# UNITED STATES PATENT AND TRADEMARK OFFICE

APPLICATION NO.	FILING DATE	FIRST NAMED INVENTOR	ATTORNEY DOCKET NO.	CONFIRMATION NO.
10/764,571	01/27/2004	Alain Gauthier	713-1029	9023

<b>Office Action Summary</b>	<b>Application No.</b> 10/764,571	<b>Applicant(s)</b> GAUTHIER, ALAIN	
	<b>Examiner</b> David C. Reese	<b>Art Unit</b> 3677

### **DETAILED ACTION**

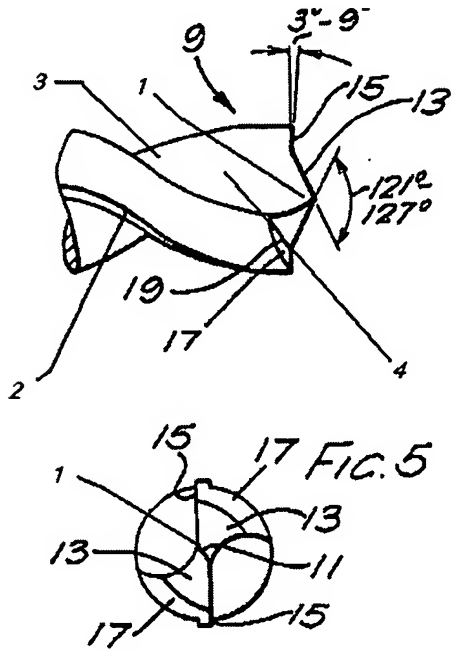
As for Claim 1, West et al. teaches of an anchor for friable material, said anchor comprising

a roughly cylindrical body (222 in Fig. 7B)

a drilling portion (below 204 in Fig. 7B) provided, at a free end of the body, with drilling teeth (three teeth below 204 in Fig. 7B),

a bearing flange (212 in Fig. 7B) at the other end of the body;

and an external screw thread (threads between 222 in Fig. 7B) wound around the body (222 in Fig. 7B) in one direction;

the drilling portion (below 204 in Fig. 7B) being configured as a portion of a drill bit, wherein the drill bit portion (below 204 in Fig. 7B) has two helical flutes (204 on the right, and the other on the upper left in Fig. 7B) in the same direction as the external screw thread (between 222 in Fig. 7B), each of said flutes opening onto a single flat surface (below 204 on the right, and the other on the left in Fig. 7B) forming a wall.

The difference between the claim and West et al. is the claim recites: that the flat surface of the flute forms the walls of both a central drilling tooth and one of two lateral drilling teeth. Mulroy et al. discloses a drilling portion similar to that of West et al. In addition, Mulroy et al. further teaches of each of flutes (3 in the Figure below) opening onto a flat surface (4) forming the walls of both a central drilling tooth (1) and one of two lateral drilling teeth (15). It would have been obvious to one of ordinary skill in the art, having the disclosures of West et al. and Mulroy et al. before him at the time the invention was made, to modify the drilling portion of West et al. to have the flat surface of the flute opening form the walls of both a central drilling tooth and one of two lateral drilling teeth as in Mulroy et al. One would have been motivated to make such a combination because such a configuration of the drilling portion allows a more concrete engagement of a work piece and thereby allowing a more efficient drilling event.
